Exhibit 45
LMA H-157

SUBJECT: Local Map Amendment Application H-157
Paramount Self Storage, LLC

**PARAMOUNT SELF STORAGE LLC
LOCAL MAP AMENDMENT H-157
FOREST CONSERVATION PLAN NO. F20240710
CONDITIONAL USE NO. CU202501**

Figure 9: Rendering of Phase 2 View from Paramount Drive

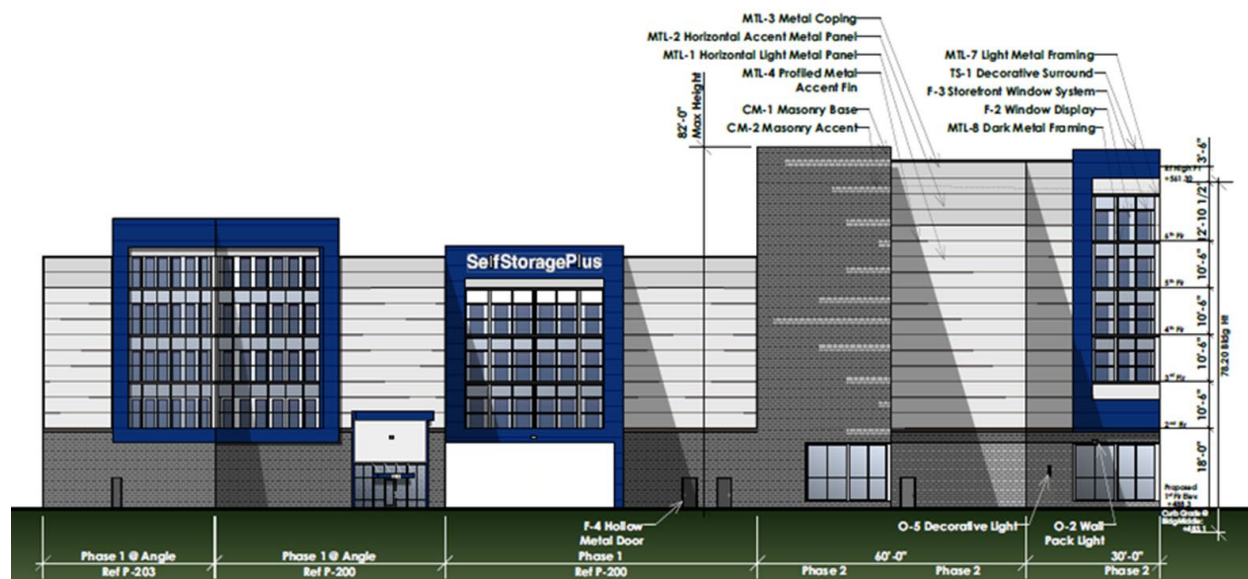
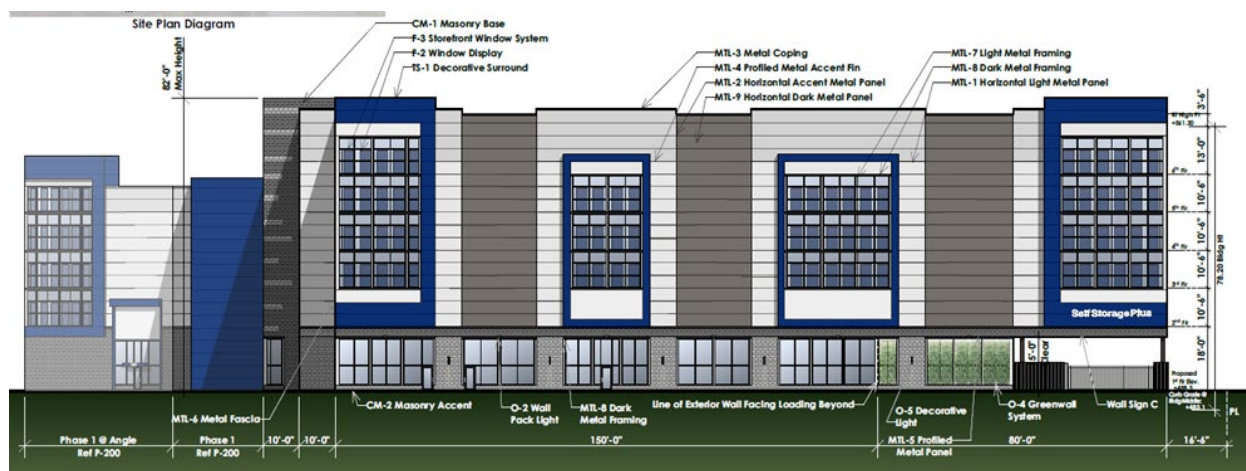
2. *The building for Phase 2 is six stories high, which is taller than anything nearby. It would seem much more reasonable to have both structures be only 4 stories tall. This is an even bigger concern when you take into account that the overall structure of both buildings will basically take up the entire site. It will be a huge mass in that area.*

The Sector Plan envisions this area as one that can accommodate larger-scale buildings and more substantial site coverage, helping to establish a new street wall and urban character. The current zoning allows for a maximum height of 120 feet, which remains unchanged under the proposed CRTF-2.75, C-2.75, R-1.5, H-120 zoning designation. This is consistent with surrounding zones, which also permit up to 120 feet in height.

While the proposed Phase 2 building is six stories (approximately 80 feet), it does not reach the maximum allowable height. This approach allows the project to remain compatible with both existing and future development patterns.
